CCK-2729-24
UKHC Parking Structure #8 Expansion BP#01
Project# 2565.0
ADDENDUM #5
07/13/2023

#### **PARKING STRUCTURE 8 EXPANSION**

### **ITEM NO. 5.01**

S-100

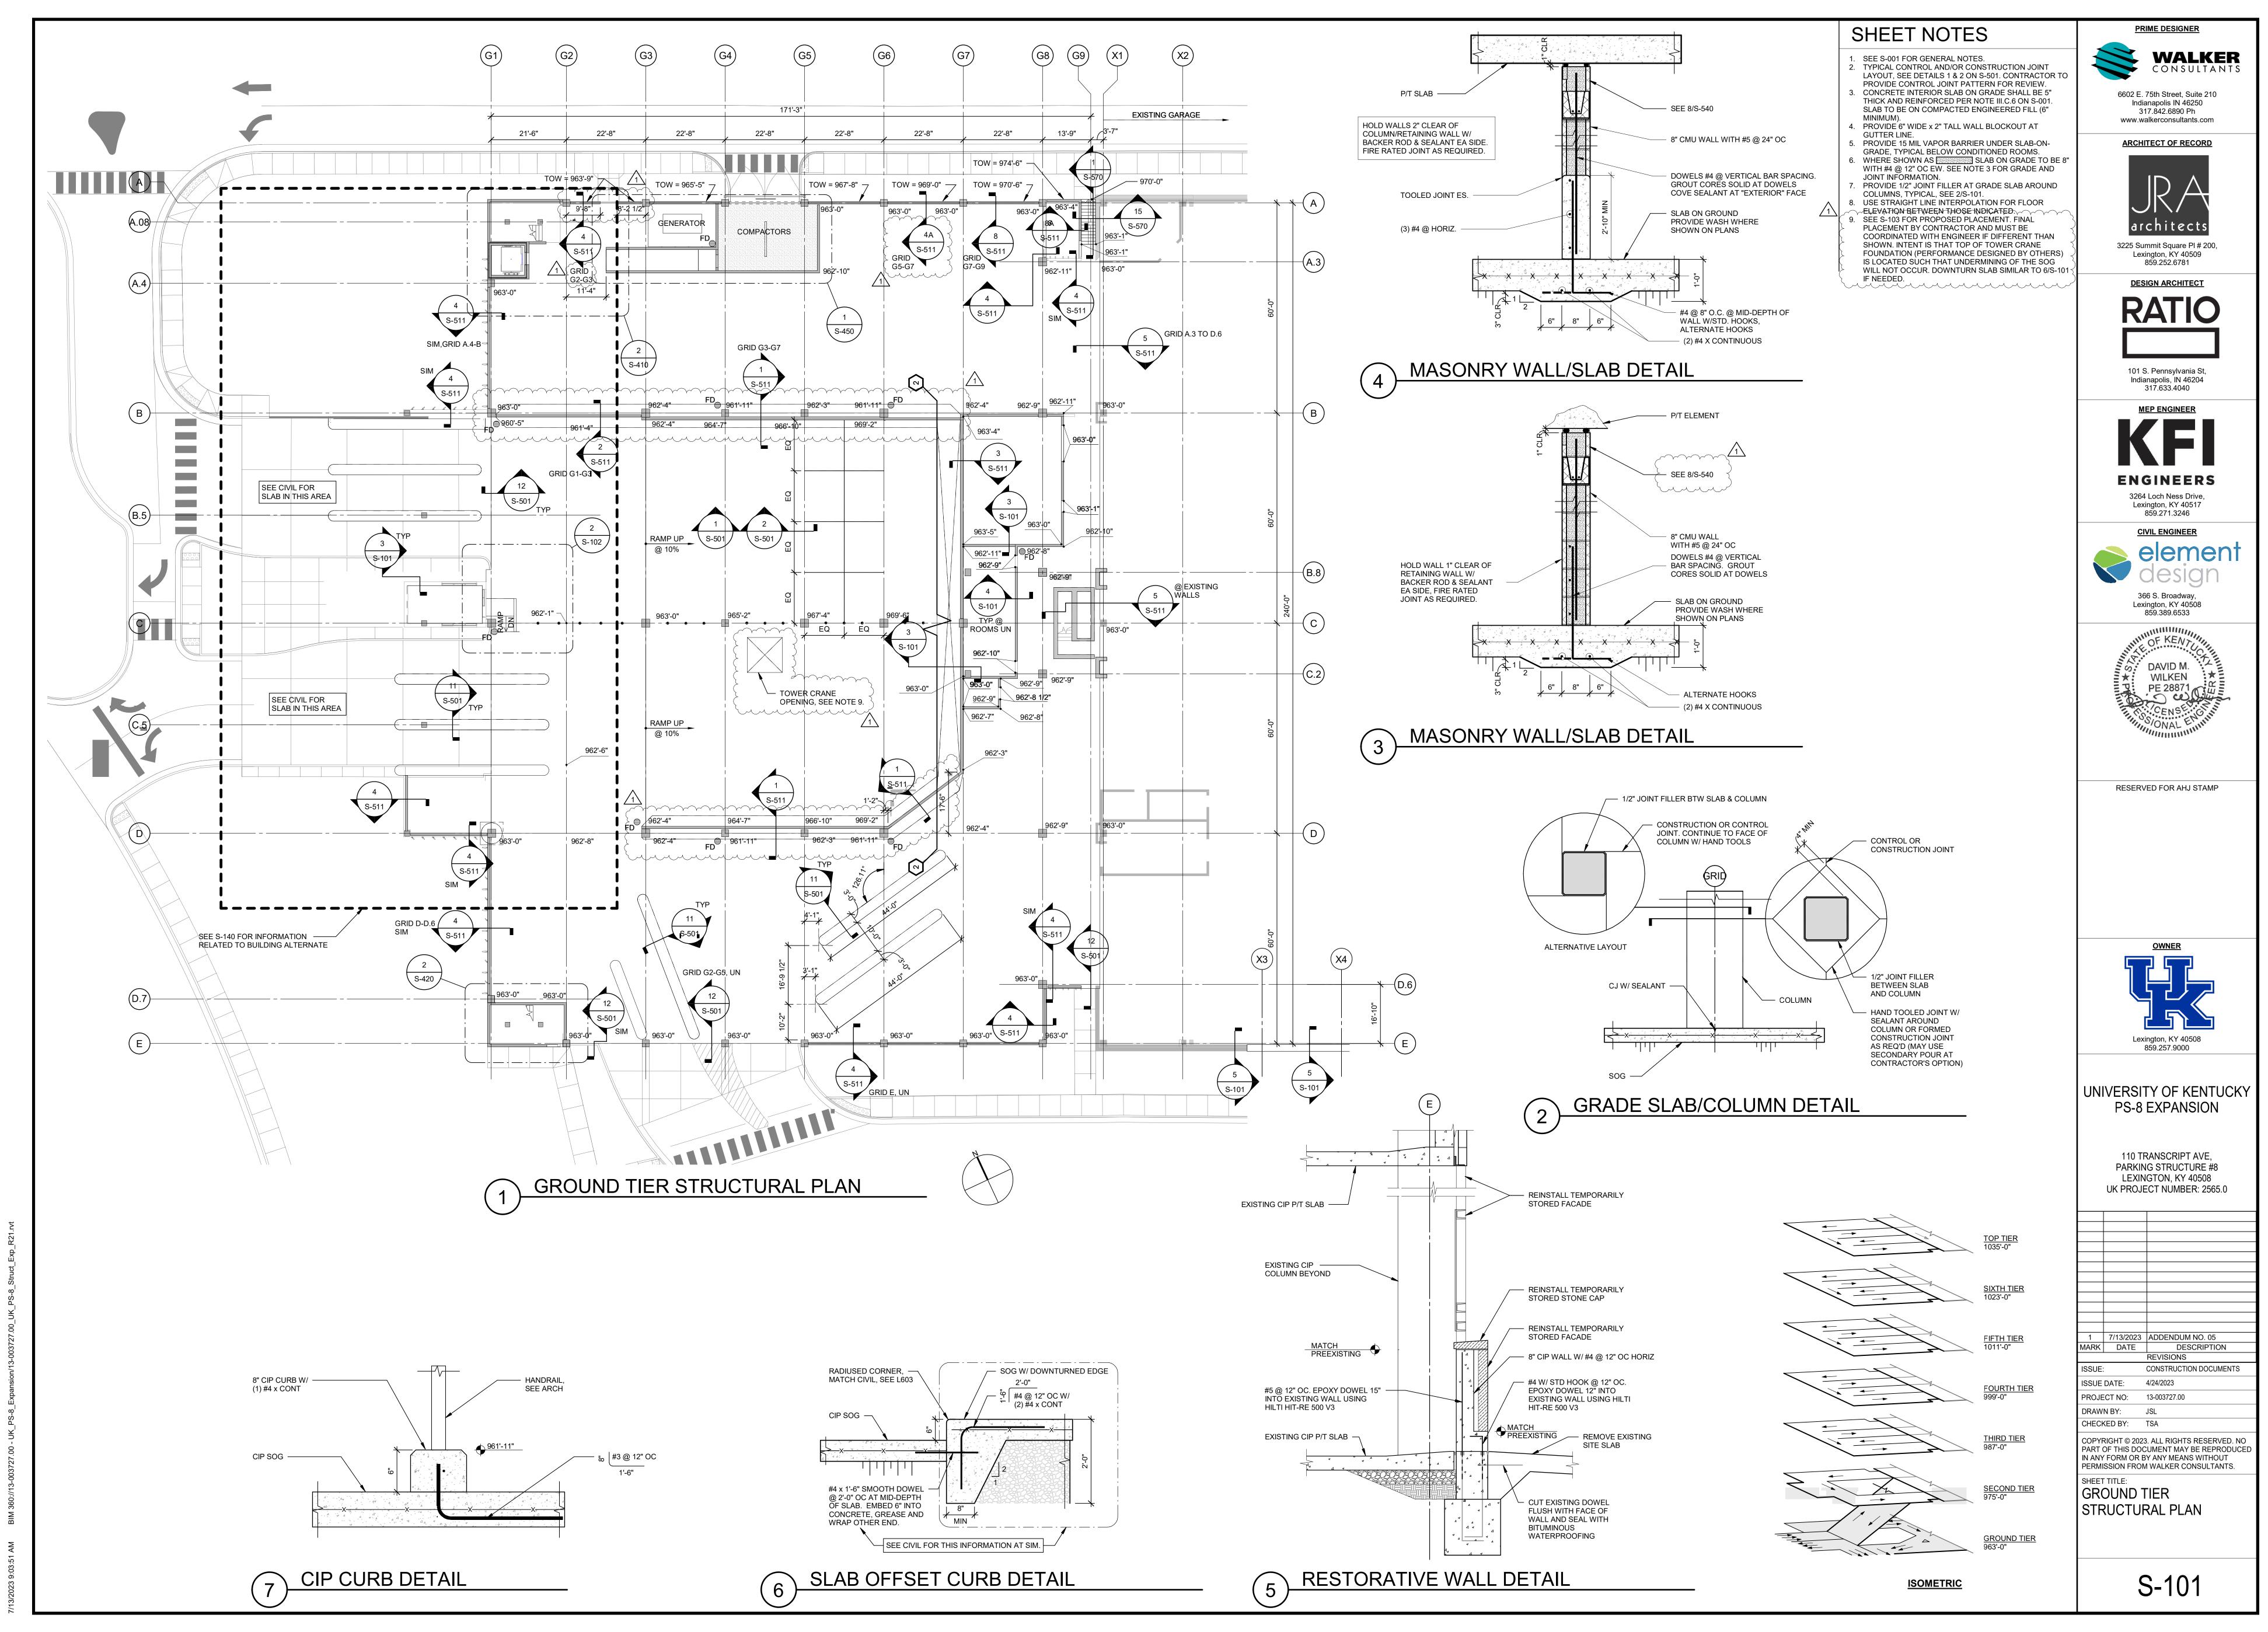
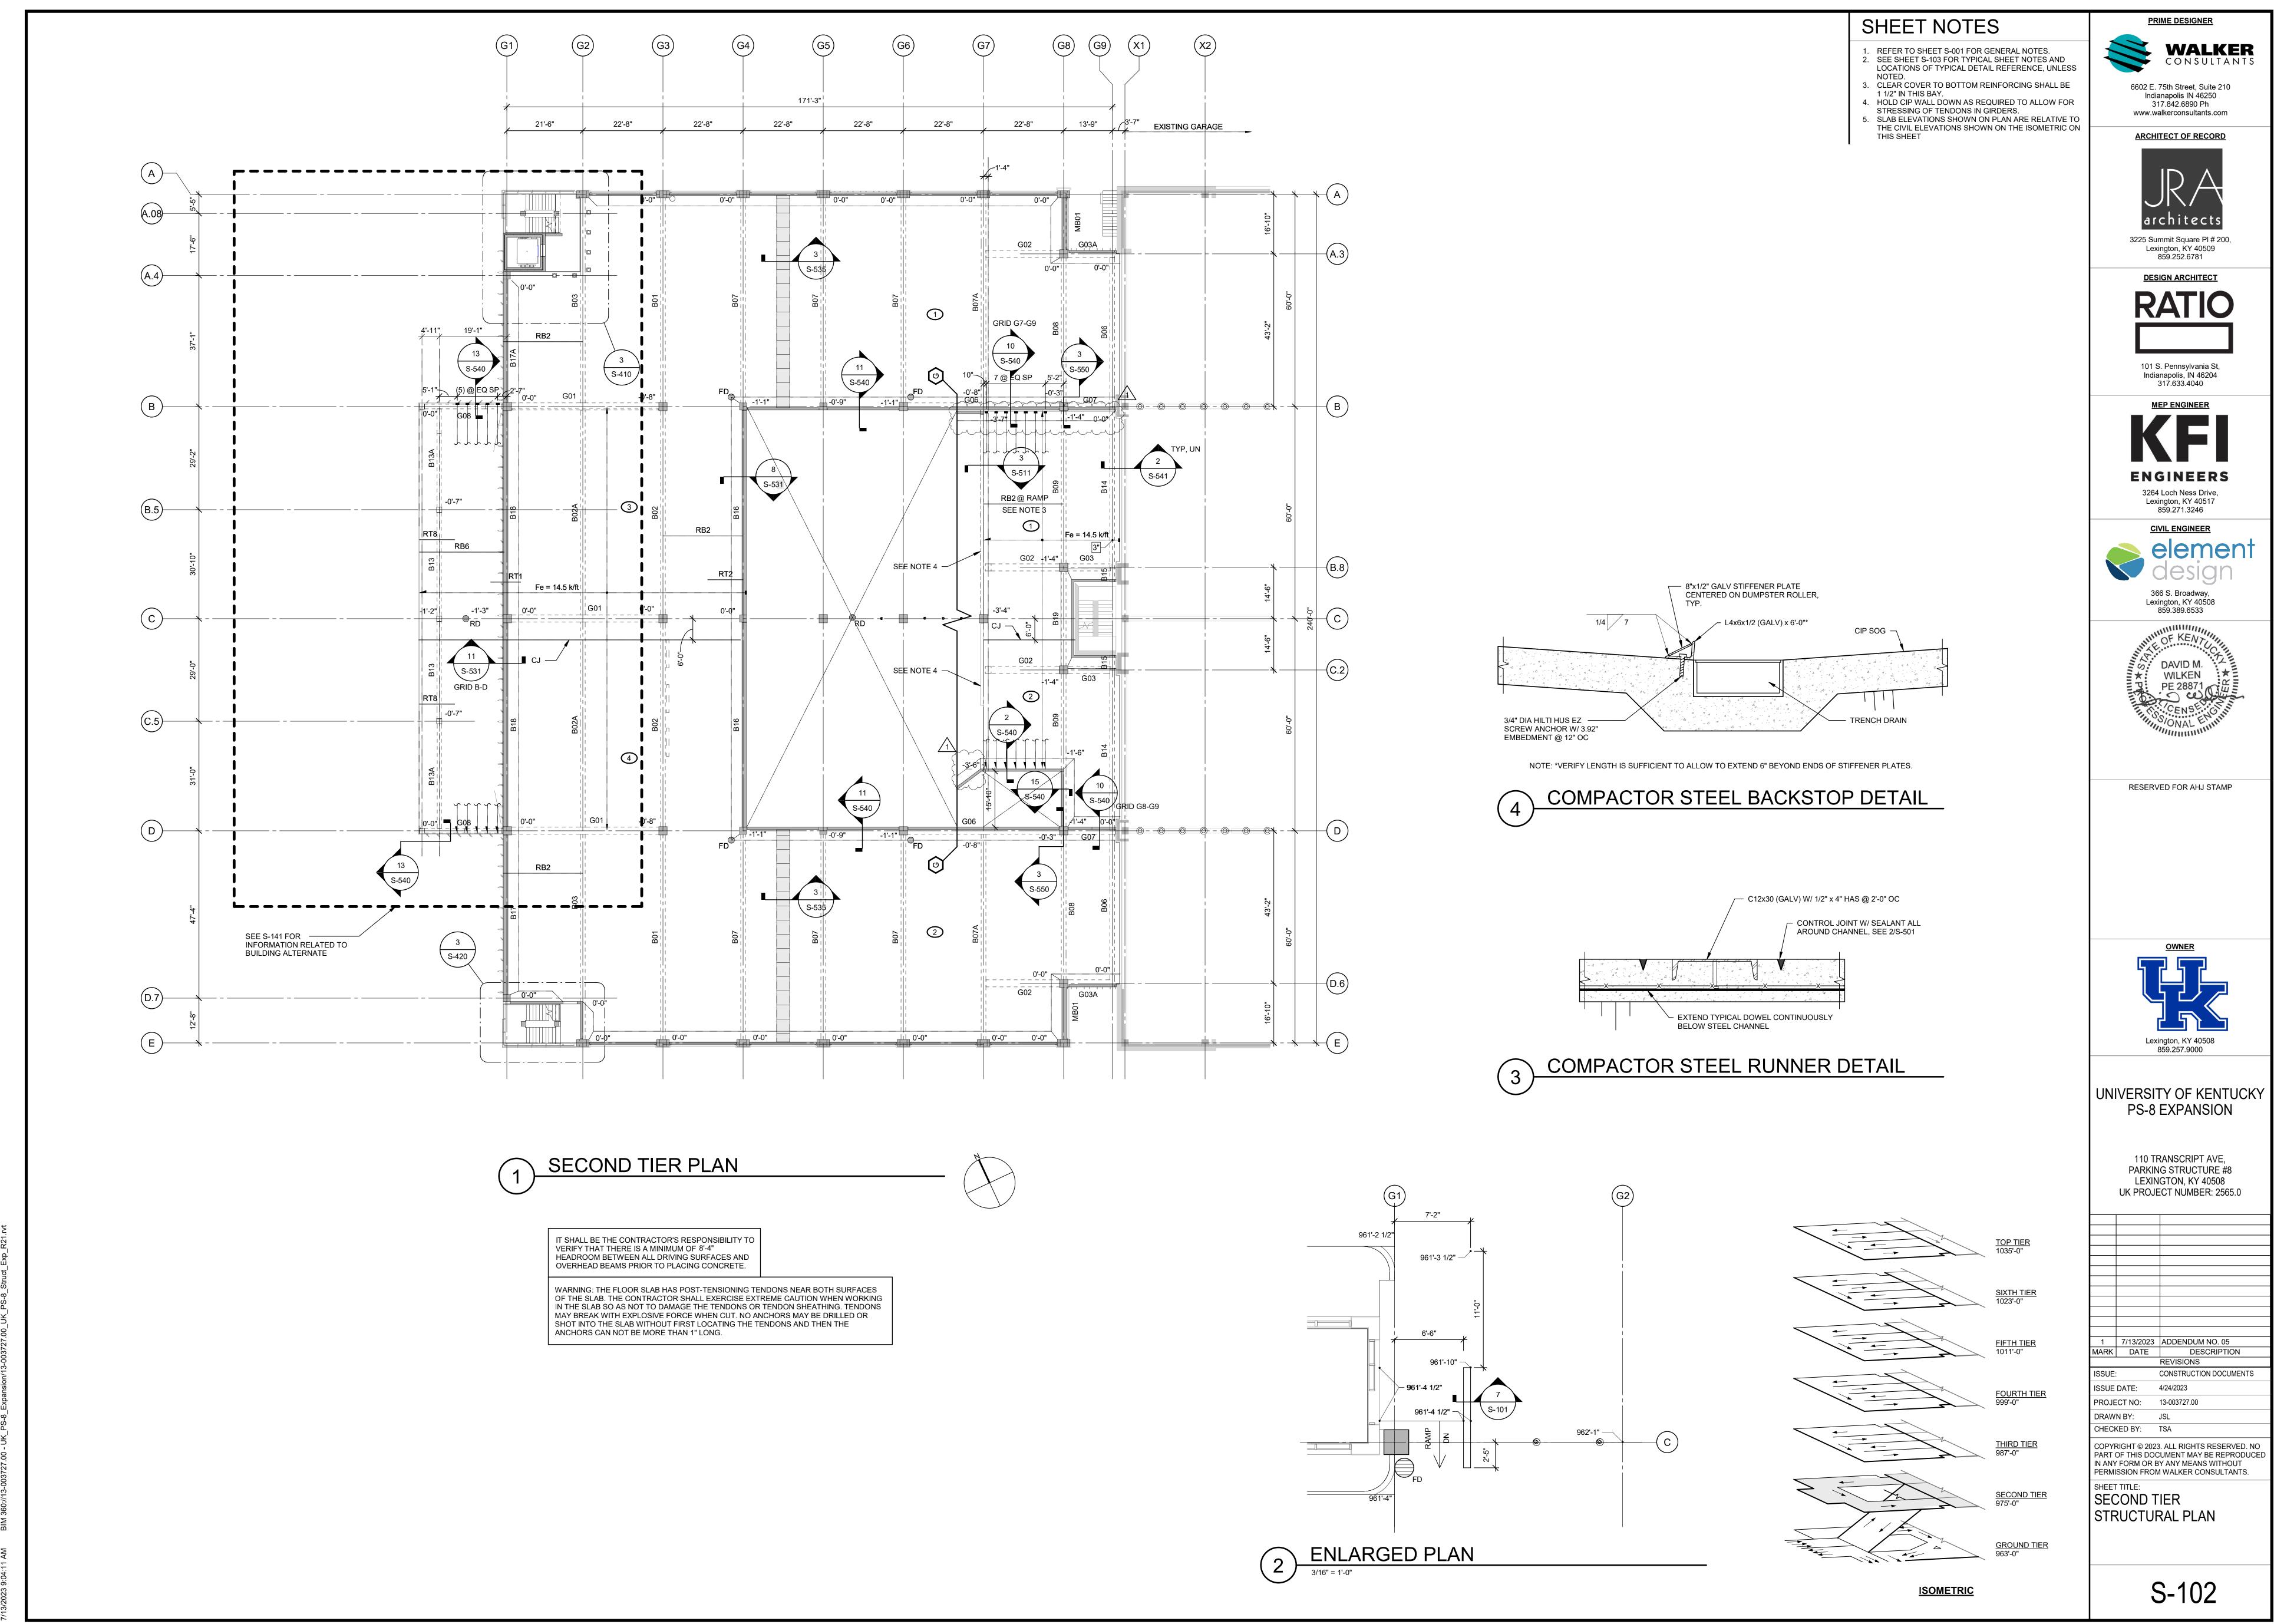
Clarified estimated bearing lengths and extents of drilled piers on S-100 as noted.
